Notice of Allowability

09/603,950

ALLRED, RUSTIN W.

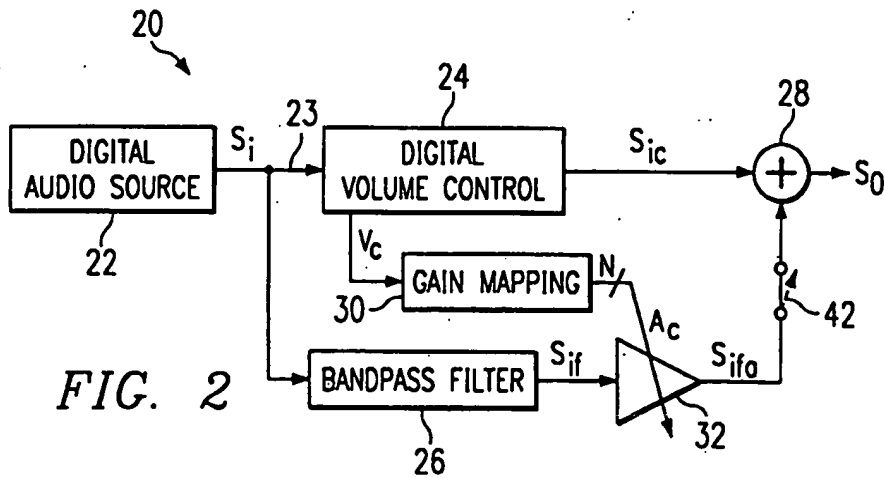
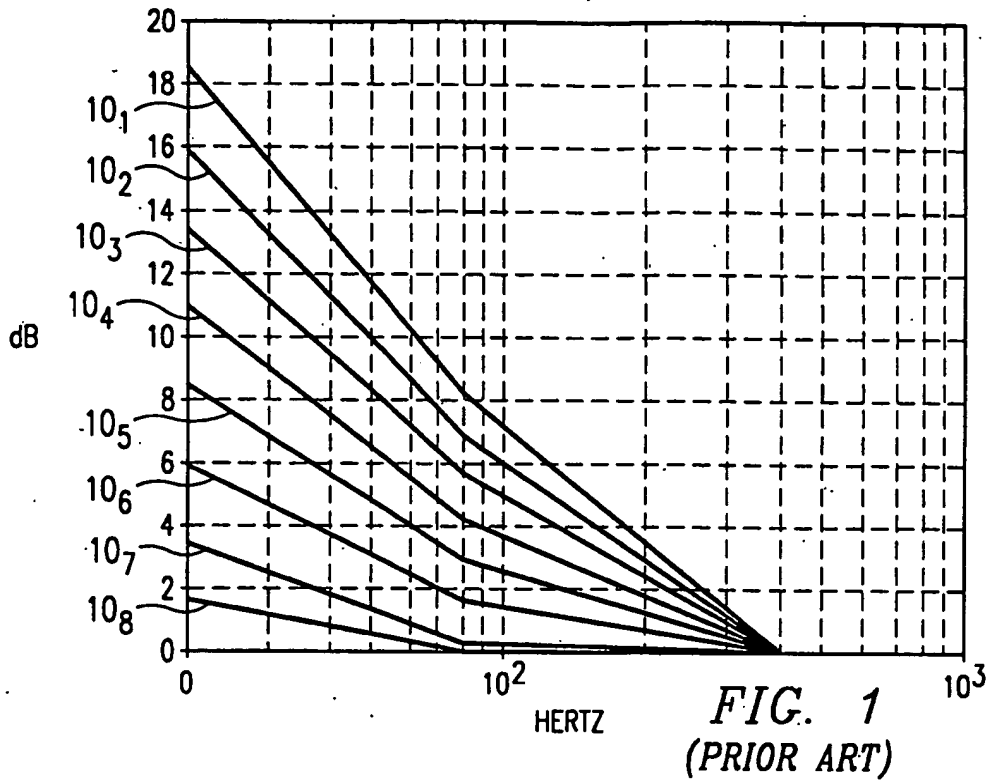
1. The drawings are objected to because Fig. 3, block 34, recites "ESTIMATE LOG₂ (S_{if})", which should be replaced with "ESTIMATE LOG₂ (V_c)". See attachment included with mark-up of Fig. 3. Corrected drawing sheets in compliance with 37 CFR 1.121(d) are required in reply to the Office action to avoid abandonment of the application. Any amended replacement drawing sheet should include all of the figures appearing on the immediate prior version of the sheet, even if only one figure is being amended. The figure or figure number of an amended drawing should not be labeled as "amended." If a drawing figure is to be canceled, the appropriate figure must be removed from the replacement sheet, and where necessary, the remaining figures must be renumbered and appropriate changes made to the brief description of the several views of the drawings for consistency. Additional replacement sheets may be necessary to show the renumbering of the remaining figures. Each drawing sheet submitted after the filing date of an application must be labeled in the top margin as either "Replacement Sheet" or "New Sheet" pursuant to 37 CFR 1.121(d). If the changes are not accepted by the examiner, the applicant will be notified and informed of any required corrective action in the next Office action. The objection to the drawings will not be held in abeyance.
